ABUTMENT PLAN

LATEST REVISION DATE 10-13 APPROVED BY BRIDGE ENGINEER <i>Thomas E. McQuinn</i>	
	STANDARD DESIGN - 24' ROADWAY, 3 SPAN BRIDGES CONTINUOUS CONCRETE SLAB BRIDGES DECEMBER, 2008
	ABUTMENT BACKFILL DETAILS FOR 0° SKEWS
J24-44-06

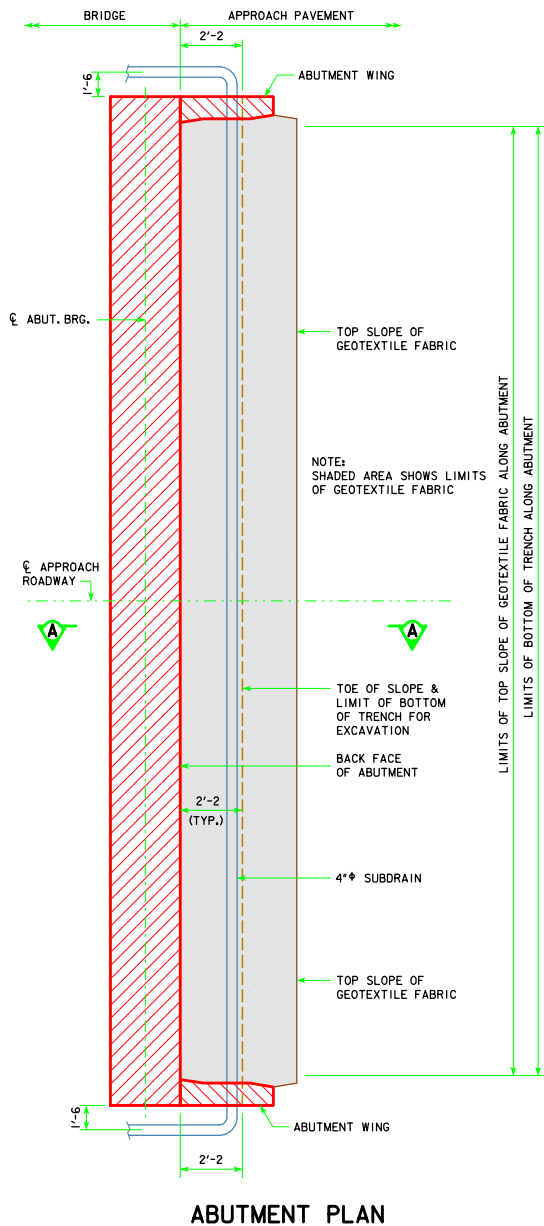
REVISED 10-13 -- EXCAVATION LIMIT ON THE FRONT FACE OF THE ABUTMENT WAS CHANGED TO A 3'-0" LIMIT. THE APPROACH FILL WAS IDENTIFIED AS THE GRADING SURFACE.
